ADDENDUM NO.2

DATE: May 31, 2019
PROJECT: Paragould Fire Station #1
Paragould, Greene County, Arkansas
ETC Project No.: 15032CPARA

SURVEY BY:
DESIGN BY: GLA
DRAWN BY: GLA
CHECKED BY: GLA
DATE
MAY 06, 2019
JOB NO: 150302CPARA
NAME: APPARATUS ROOM WALL DETAILS
SHEET
A5.4

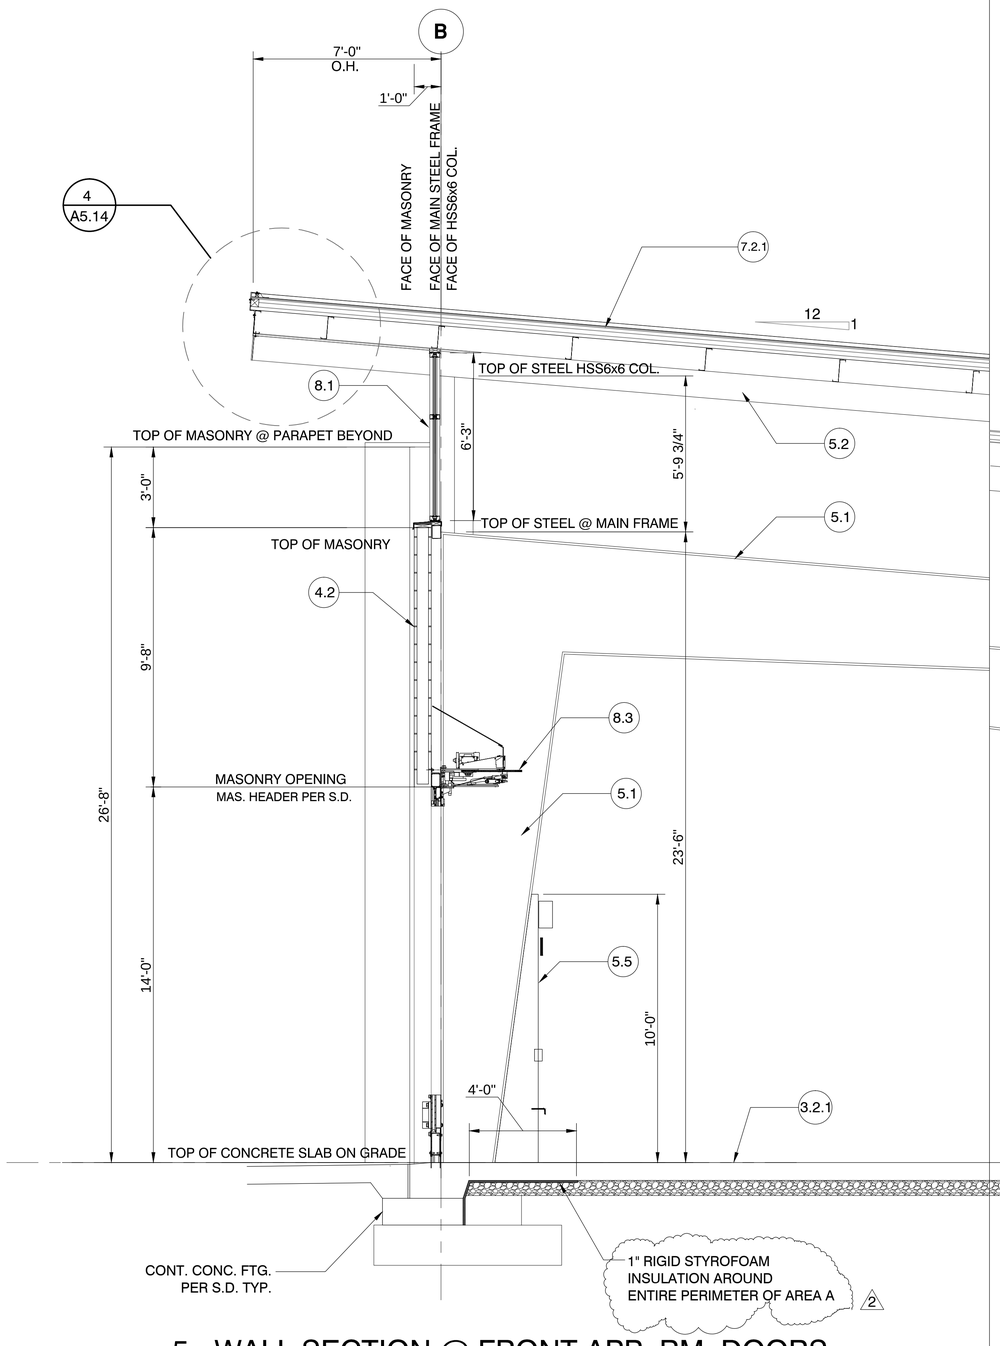
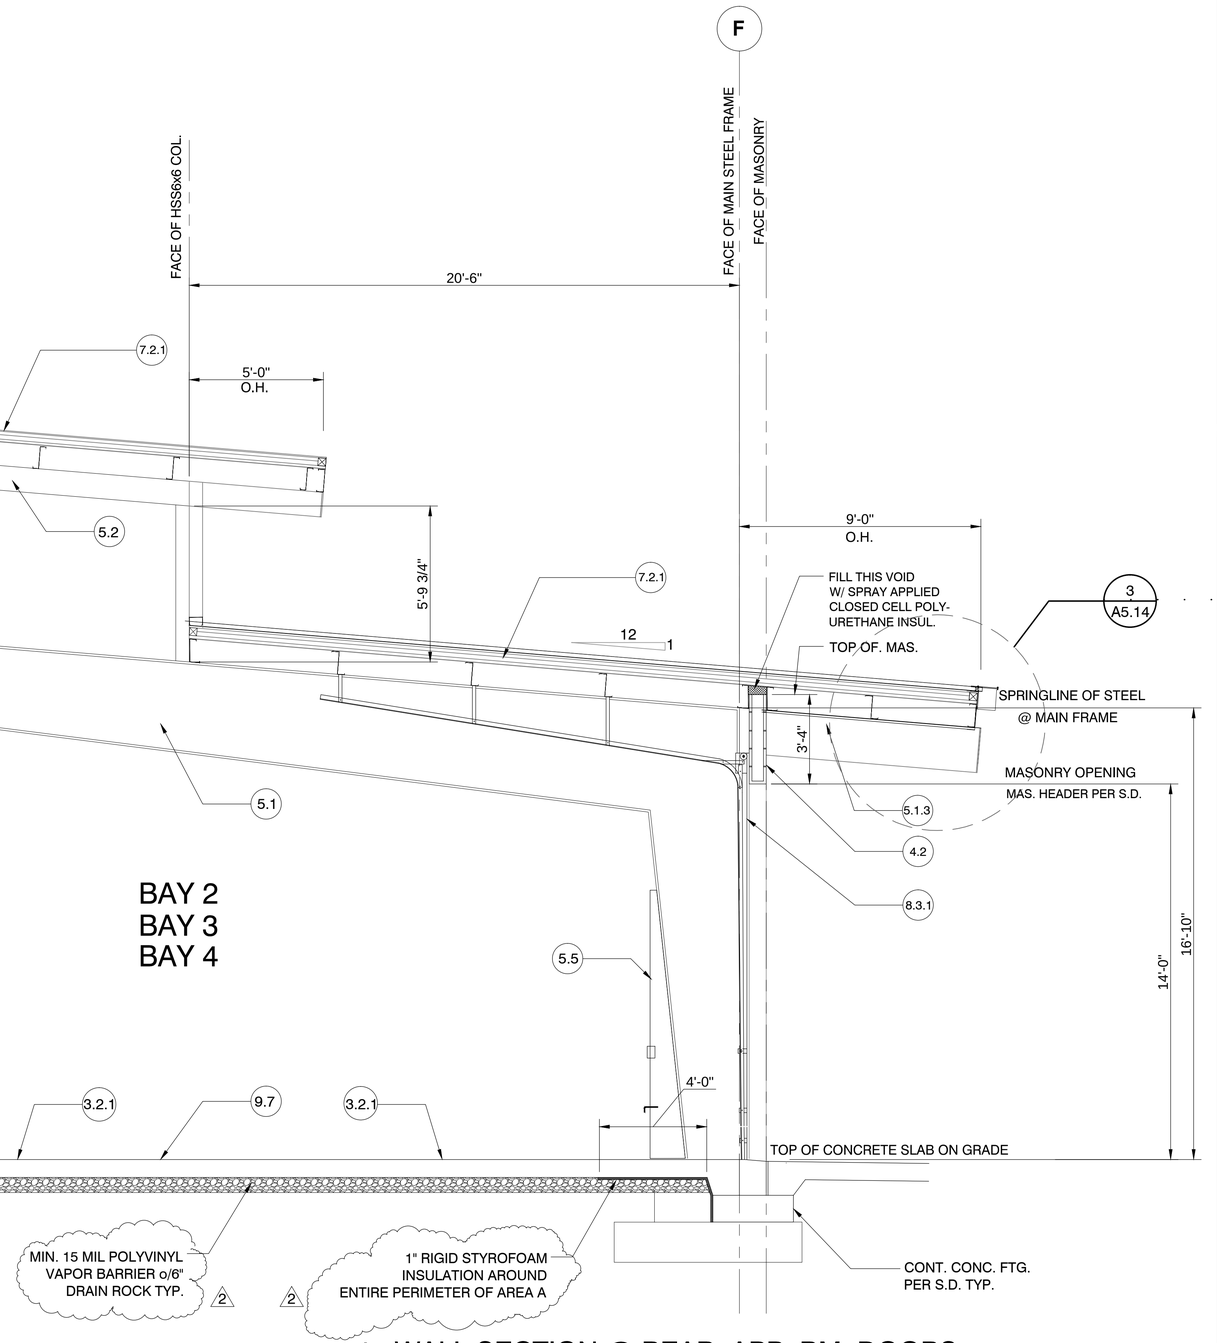
1. Clarified perimeter insulation

2. Clarified Vapor Barrier requirement
